In the Matter of)	
)	
Application of Midtown Radio)	File No. BNPL-20131115ABH
for New Low Power FM Station in)	Facility ID No. 196604
Sacramento, California)

**PETITION TO DENY, OR IN THE ALTERNATIVE,
REQUEST FOR LICENSE CONDITION**

**Engineering Statement
Petition to Deny Filed Against BNPL-20131115ABH
New LPFM Station on Channel 221L1 at Sacramento, California
December 2013**

Exhibit 1

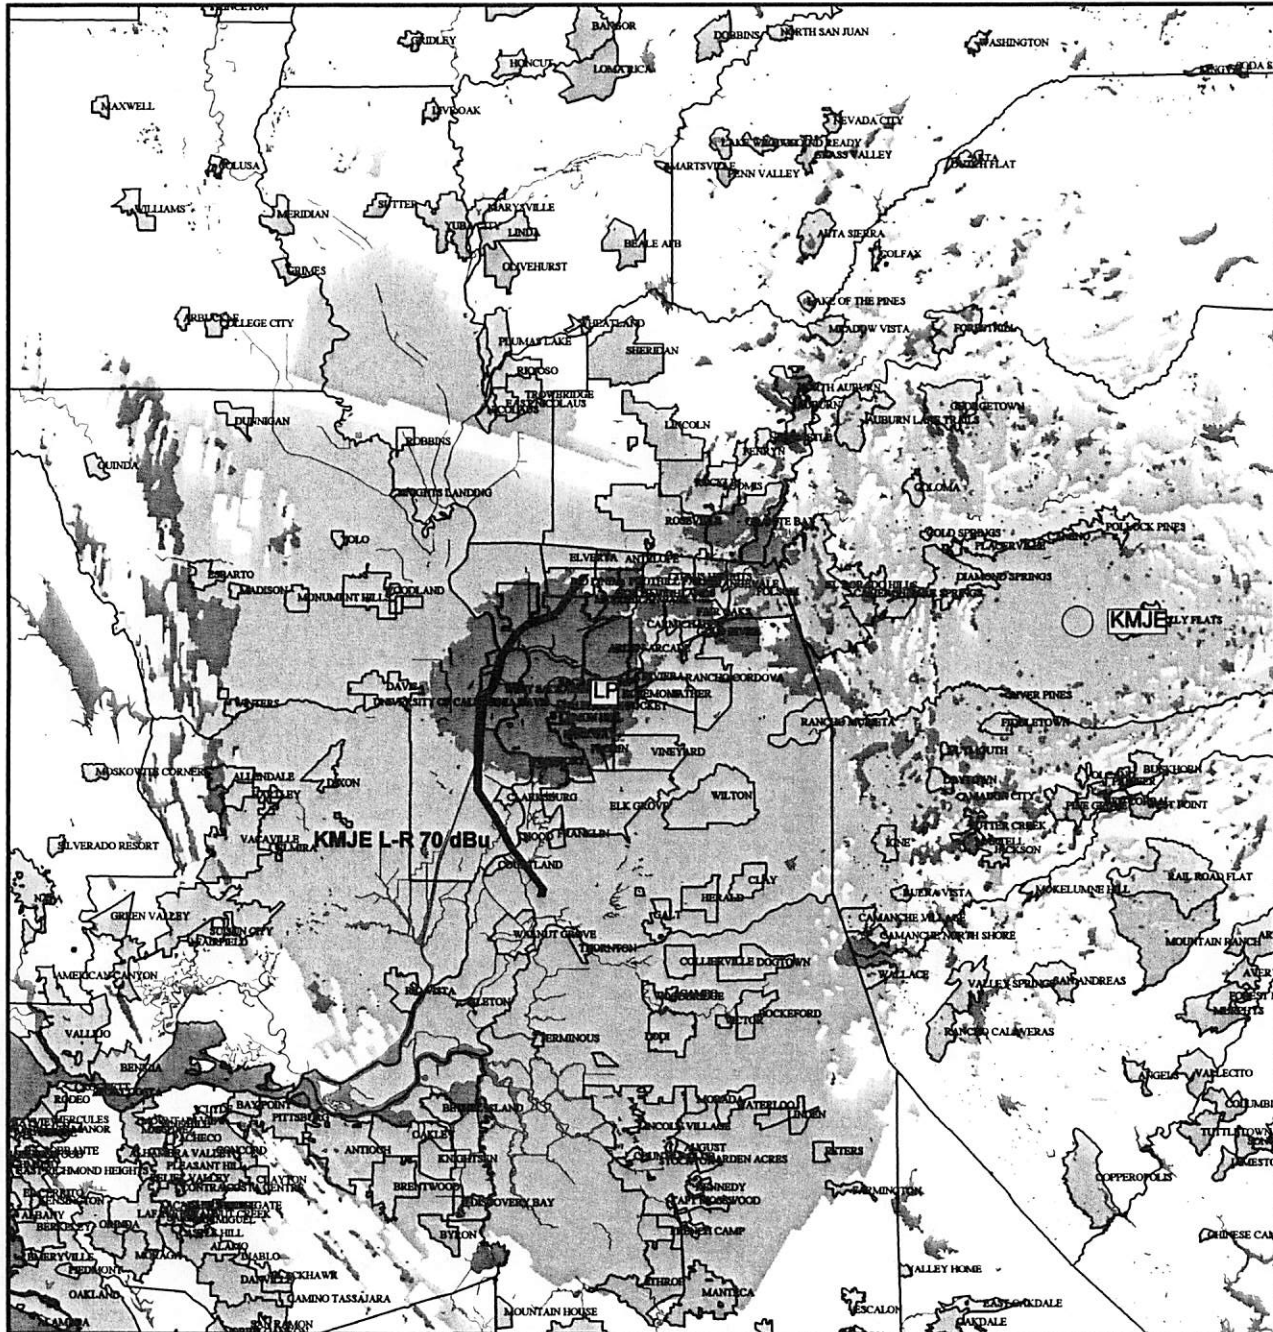
On the attached map Exhibit 1, areas which are shaded either red or green are predicted to receive a signal strength of at least 60 dBu from KMJE. Areas shaded green are not predicted to be subject to interference from the Sacramento LPFM, using a D/U signal ratio of 20 dB for cochannel operation. Areas shaded red are predicted to be subject to interference from the Sacramento LPFM. The interference is predicted to affect 1,002,583 persons who would otherwise receive at least a 60 dBu signal from KMJE.¹

Exhibit 2

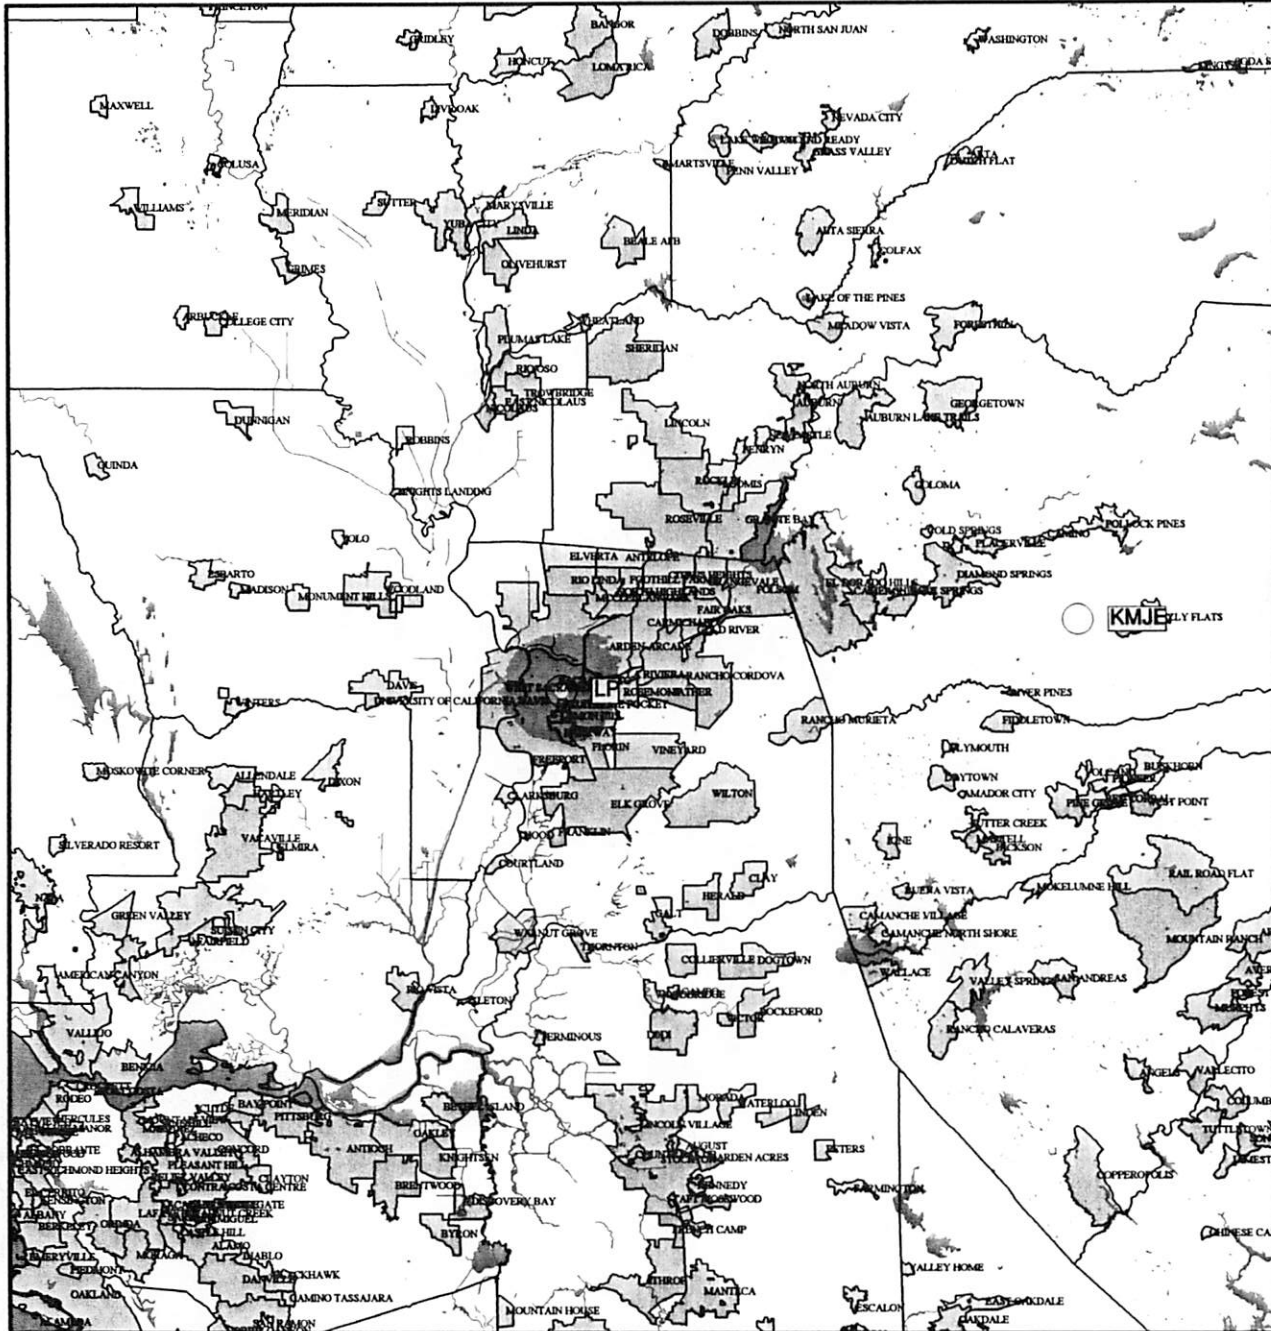
On the attached map Exhibit 2, areas which are shaded either red or green are predicted to receive a signal strength of at least 60 dBu from the Sacramento LPFM. Areas shaded green are not predicted to be subject to interference from KMJE, using a D/U signal ratio of 20 dB for cochannel operation. Areas shaded red are predicted to be subject to interference from KMJE. Only 8,132 persons are predicted to receive interference-free service from the Sacramento LPFM, and the LPFM station's effective service radius would be only 1 kilometer.

Exhibit 3

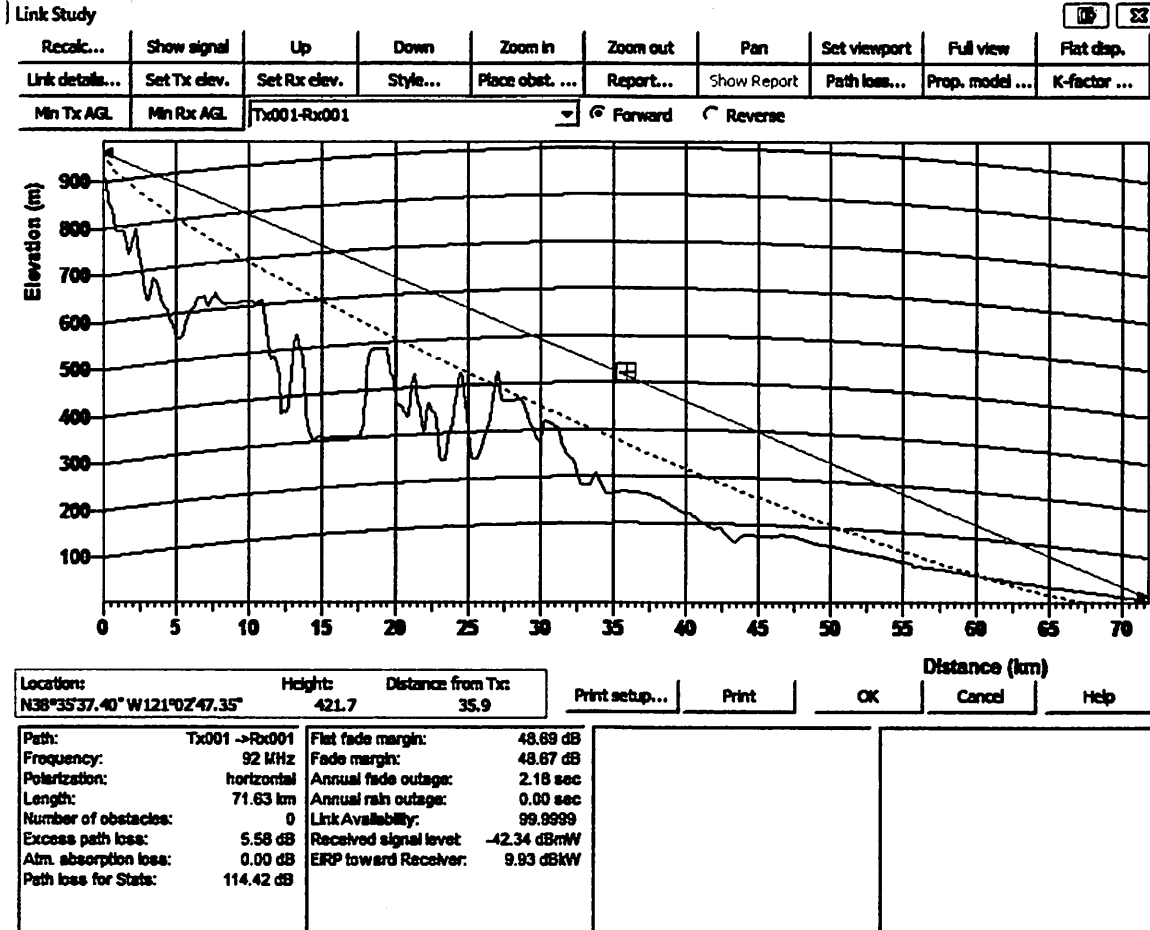
Given the nearly-identical line-of-sight conditions between the KMJE transmitter site and both locations, it is axiomatic that KMJE places at least a 70 dBu signal at Midtown's proposed transmitter site. Indeed, a point-to-point Longley-Rice study of the path from the KMJE transmitter site to the LPFM transmitter site shows that KMJE places a 71.9 dBu signal at that location. A plot of this path study is included at Exhibit 3. Additionally, Exhibit 1 depicts the location of the KMJE Longley-Rice 70 dBu contour, which extends beyond the LPFM transmitter site.

-42.34 dBmW is equal to 71.9 dBu at 92.1 MHz.
